GRAND RIVER SOCCER PARK JSP16-20

Consideration at the request of City of Novi and Suburban Showplace, LLC for Planning Commission's approval of Preliminary Site Plan, Woodlands Permit, Wetlands Permit and Stormwater Management Plan. The subject property is currently zoned I-1, Light Industrial and is located in Section 16, west of Taft Road and south of Grand River Avenue. The applicant is proposing two soccer fields and associated parking on site.

JSP16-20 GRAND RIVER SOCCER PARK Planning Review

Preliminary Site Plan Review

CLIENT PROJECT NO: 1616
DATE ISSUED: 05/04/16
PROJECT NO: 1616
SHEET NO: C-2

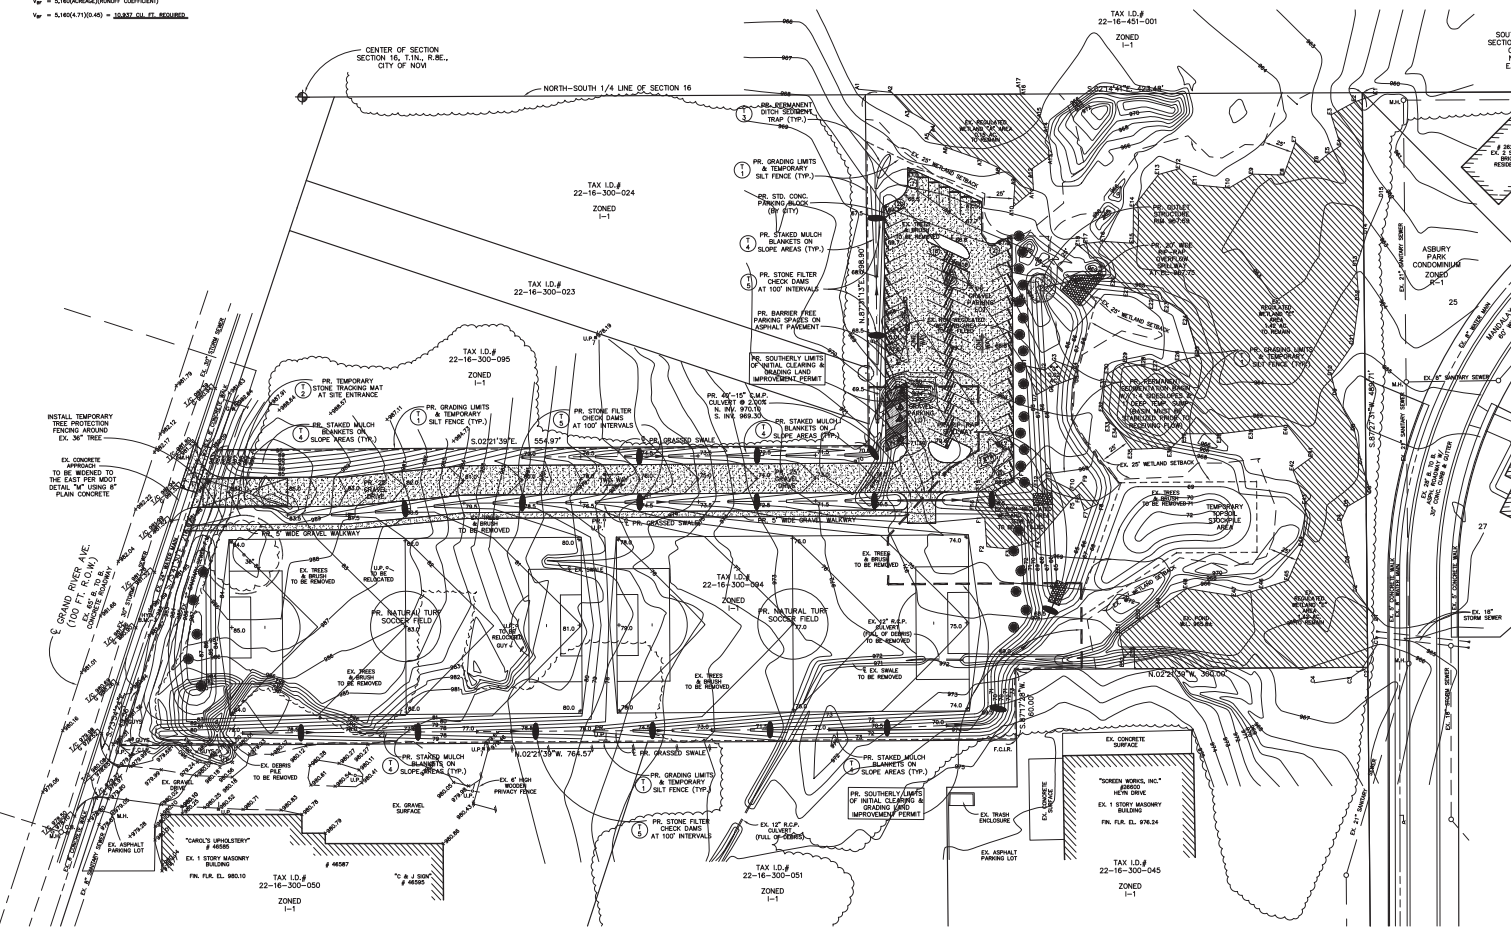
It should be noted that the Site Grading & Soil Erosion Control Plan (Sheet C-2) indicates an area of temporary proposed grading limits. It is our understanding that the applicant is requesting authorization to clear the site within the proposed temporary grading limits as soon as possible.
